STRUCTURAL ADDENDUM-No: SA-04

Re: 321 John Street, Cobourg, ON
Clarifications & Updates to Structural Documents

Description of Drawings Revised & Revisions

A FOUNDATION PART PLAN
S201-B 1:50

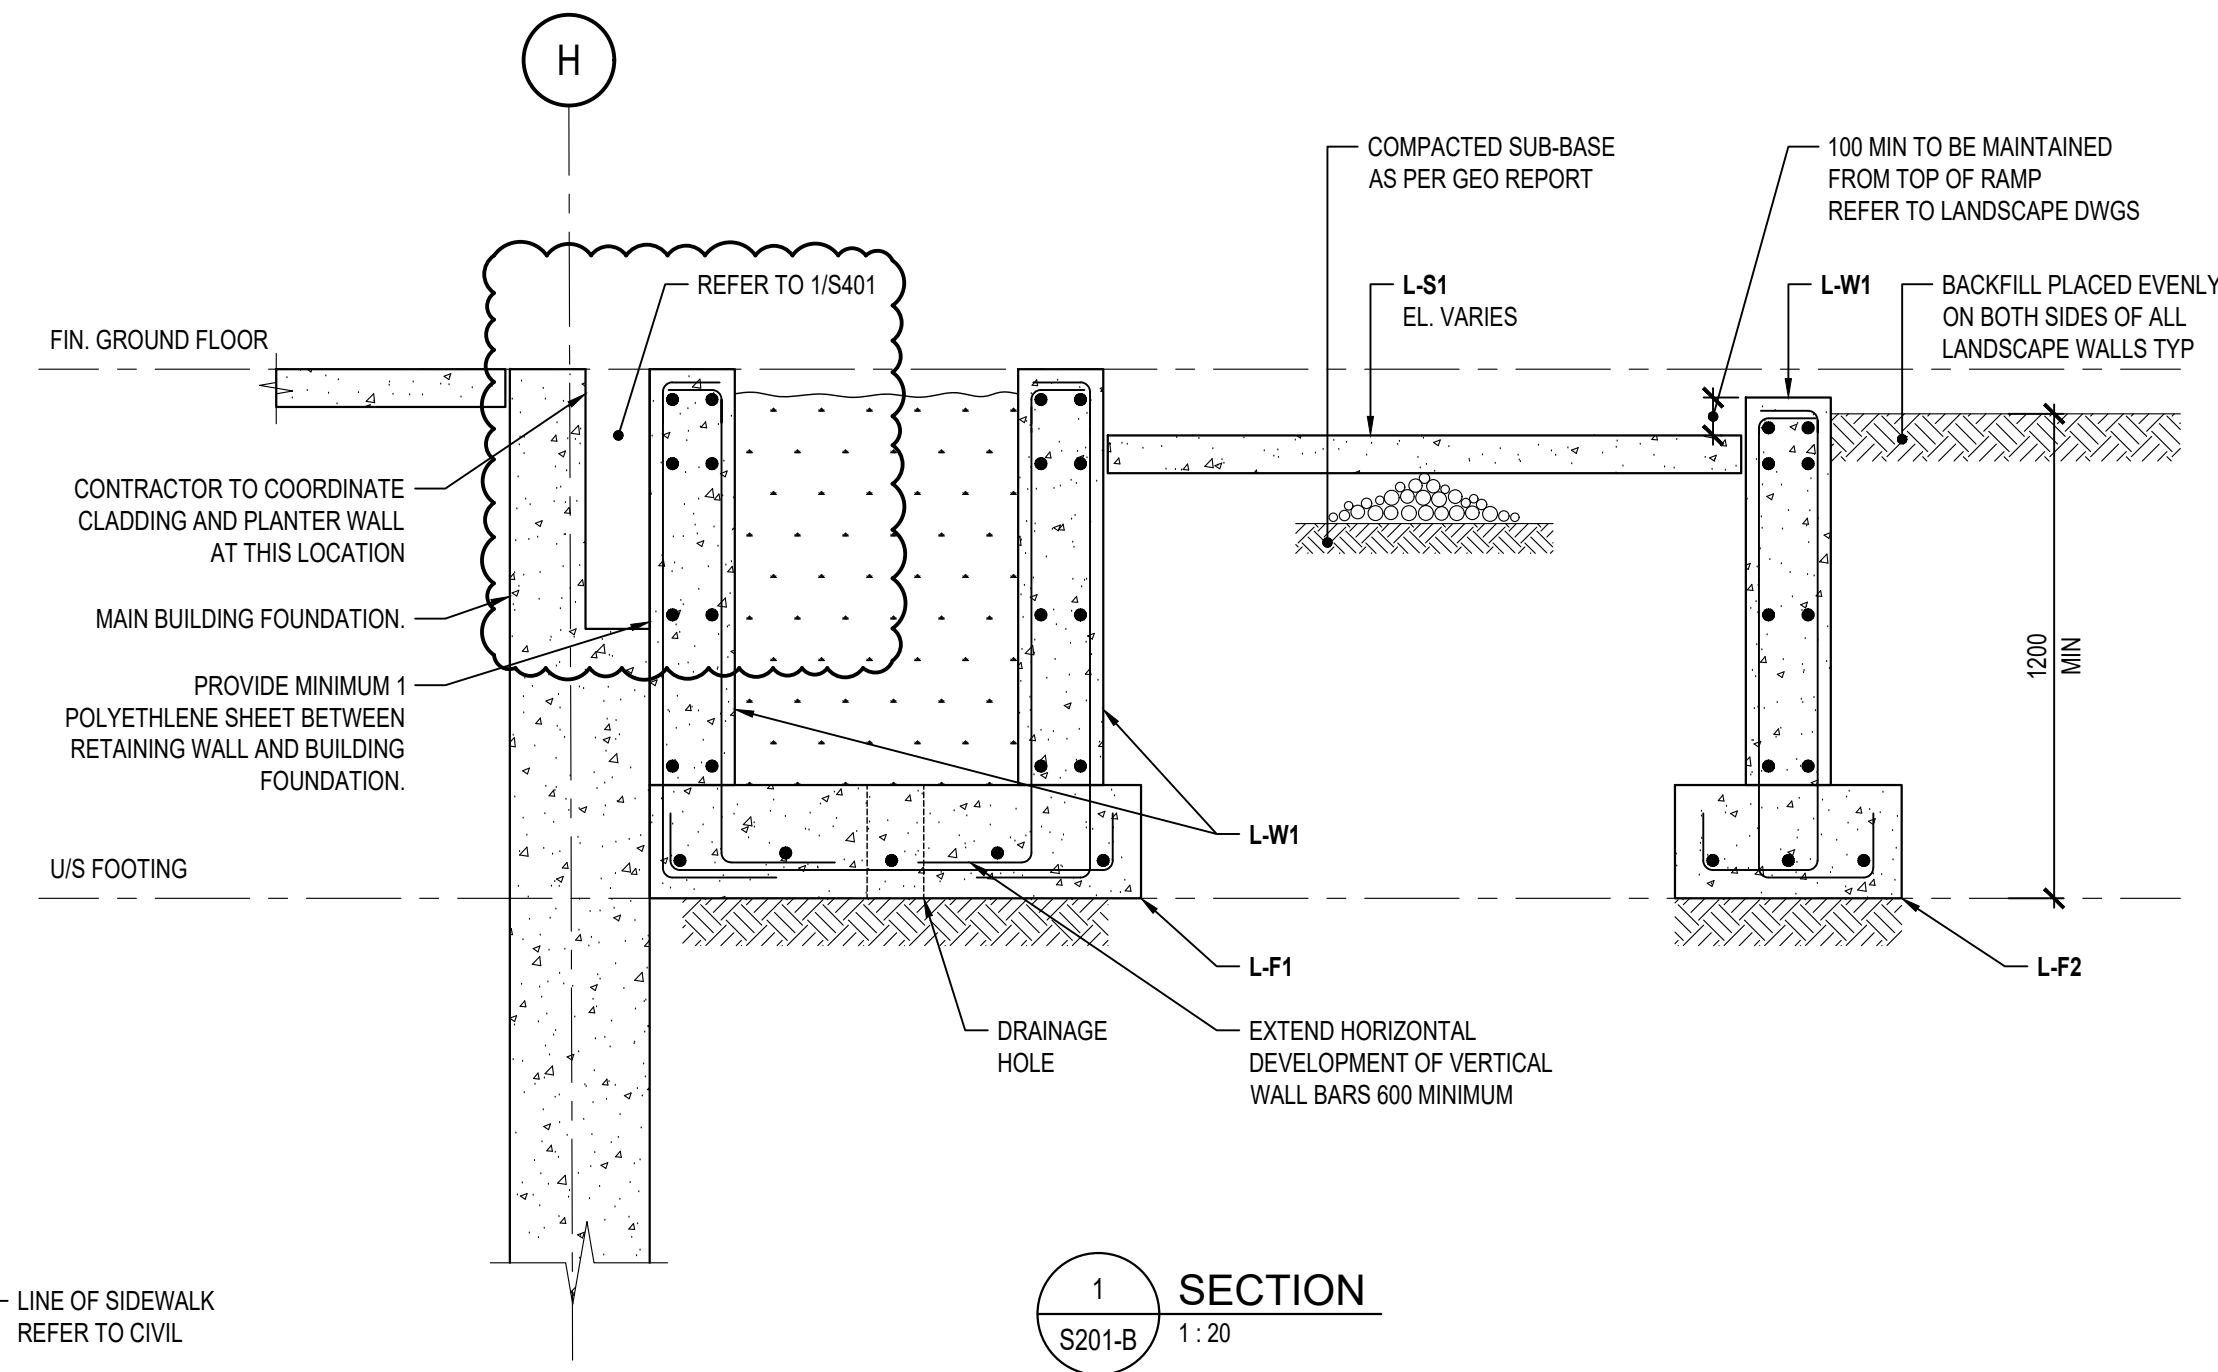
1.0 S201-B Foundation Part Plan

- 1.1 Frost slab extended to top of stairs.
- 1.2 Extent of slab on grade reduced.
- 1.3 Visual indication of precast bench changed to dashed box.
- 1.4 Visual indication of brick ledge shown in section 1/S201-B.
- 1.5 6/S201-B section marker added to plan for clarity.

SHEET NO:
S401

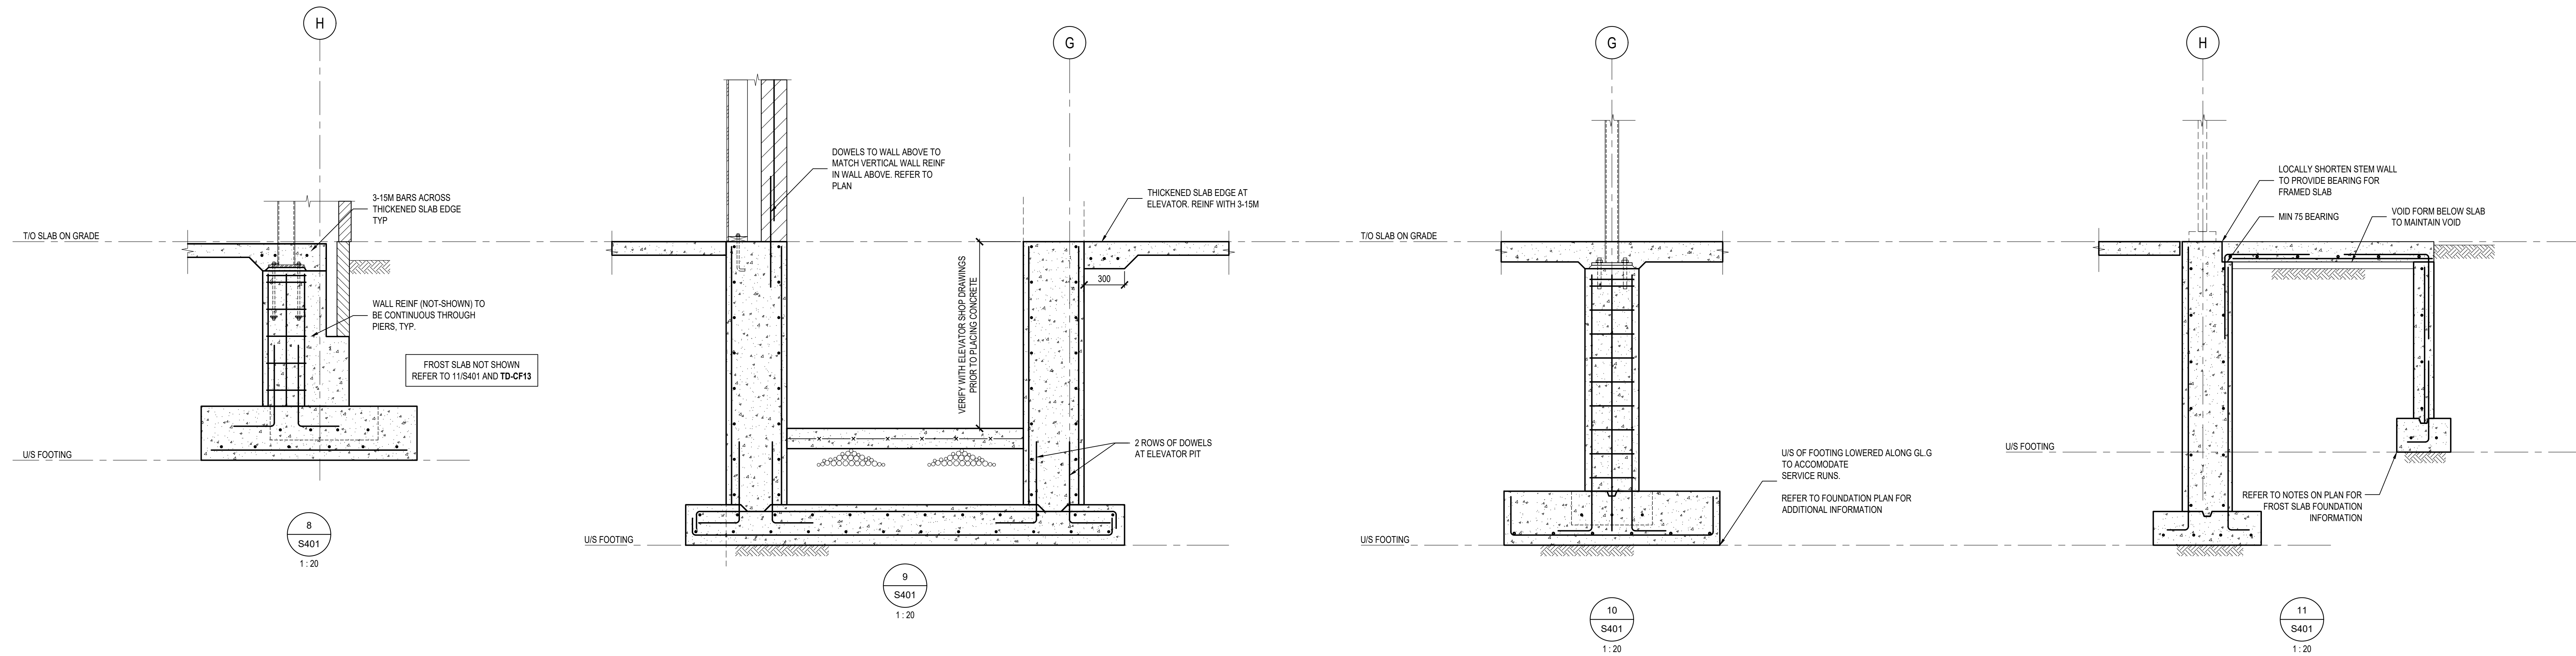
2.0 S401 Sections and Details

- 2.1 Added below grade CMU reinforcement detail to section 1/S401.
